Campaign No. 2012070002, September 2012

SUBJECT: **Models 164, 171, 203, 204, 207, 209, 211, 212, 216, 219, 221, 230, 251, 463**
Engines 272 and 273
Model Years 2005 - 2011
Retrofit Adapter Wiring Harness on Camshaft Adjustment Solenoids

This Service Campaign has been initiated because Daimler AG (DAG), the manufacturer of Mercedes-Benz vehicles, has determined that due to the settling properties of the seal, oil may leak from the camshaft adjustment solenoid. Dealers will retrofit four adapter harnesses onto the engine wiring harness as a precautionary measure at the next workshop visit

Figure 1

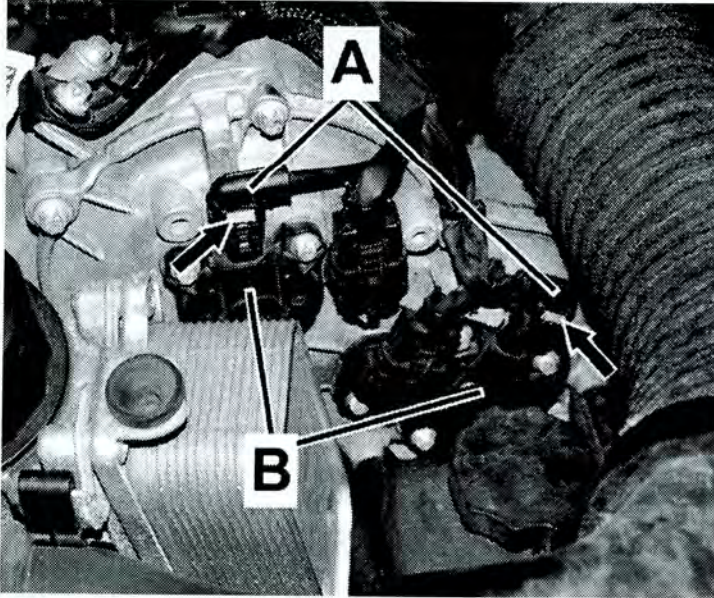
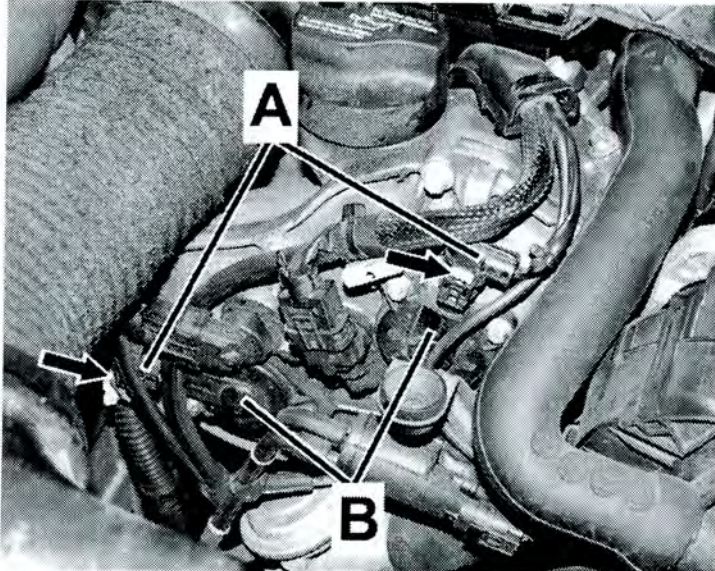
1. Remove top engine cover to get access to camshaft adjustment solenoids as required.
2. Disconnect camshaft adjustment solenoids from engine harness connectors (A, Figures 1 and 2):
 - Carefully unlock engine harness connectors (A) by squeezing and **partially** pulling out locking tabs (arrows) using pocket screw driver.
 - Disconnect camshaft adjustment solenoid connectors (A) from camshaft solenoids (B).

Figure 3

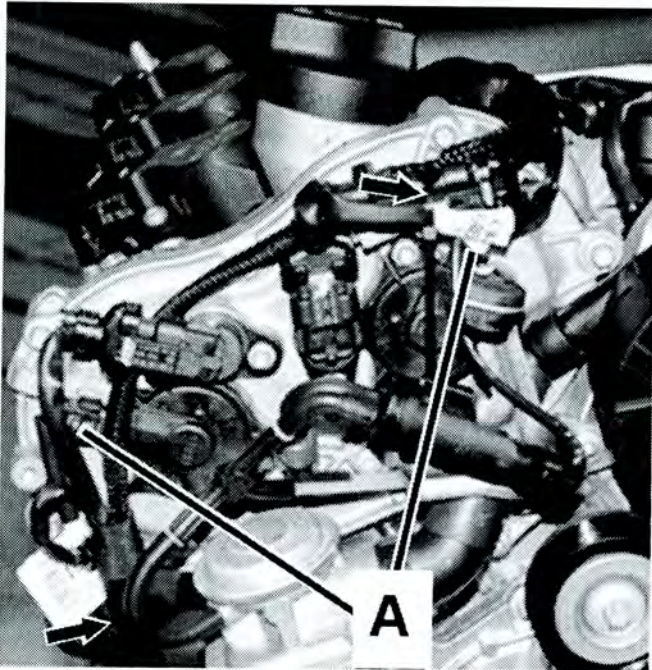
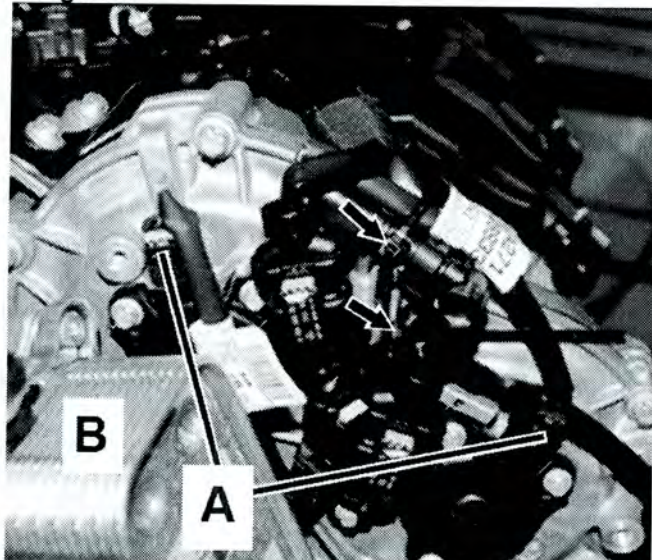
3. Connect adapter harnesses (A, Figures 3 and 4):
 - Connect adapter harnesses (A) between connector on camshaft adjustment solenoid and engine harness.
 - Push locking tabs (arrows, Figures 1 and 2) into connectors to secure (total of 8 locking tabs).
4. Secure adapter harnesses with cable ties.

Ensure harness adapters are properly secured using cable ties (arrows, Figures 3 and 4) to prevent wire chafing and/or damage from hot engine parts, (e.g. oil cooler [B]).
